Access Report

**Maitland Gaol Redevelopment
BOUTIQUE
ACCOMMODATION**
6-10 John Street
EAST MAITLAND NSW

For: Maitland City Council
Ref: PAA_23218

Figure 2 | New Work & The Affected Part

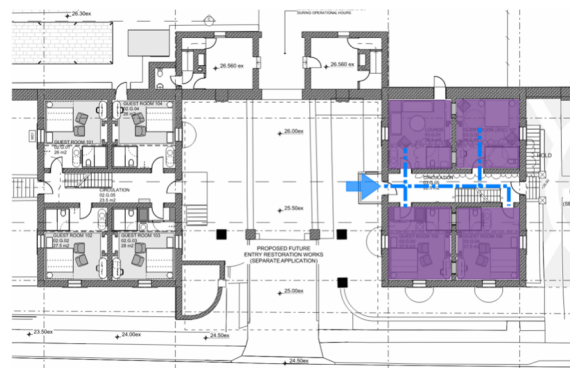
Due to the extent of refurbishment works, the affected part forms part of the new building works generally.

Figure 2 | Site Plan (in part)

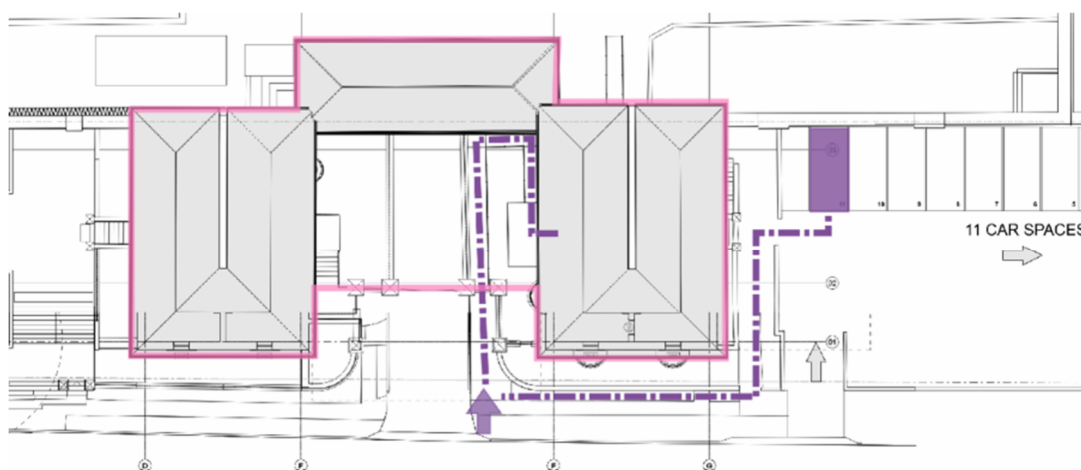
An accessible path of travel is provided to the building entrance from the allotment boundary along John Street. The existing ramp will be maintained.

The existing carparking adjacent to the proposed Boutique Accommodation, that includes two (2) accessible carparking spaces is to be retained. The existing path of travel to the building entrance facilitates wheelchair access.

The existing carparking adjacent to the proposed Boutique Accommodation is to be retained. There are two (2) accessible spaces in this location. The existing condition is appropriate to the new use as boutique accommodation.

6.5 Existing Entrance

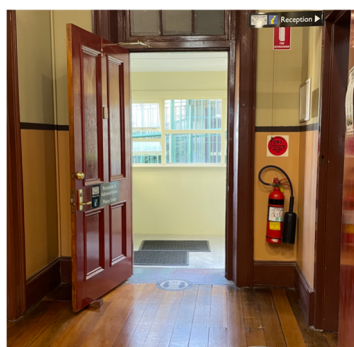
The existing entrance facilitates access for people with a disability. The clear opening width of the doorway is 930mm and the doorway has a level threshold.

Automatic sliding doors are provided for entrance to the building. The use of this type of door is encouraged as it maximizes access for persons with a disability to the tenancy.

7.11 Existing Stairs

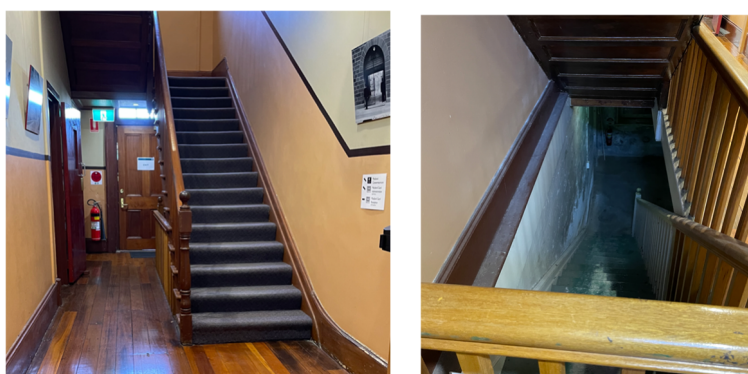
There are existing stairs within each building that provide access between levels. Accessibility features are not currently provided.

We recommend that the existing stairs be upgraded as far as possible within the heritage constraints to improve user safety. As a minimum, we recommend the provision of contrasting non-slip nosing strips to treads.
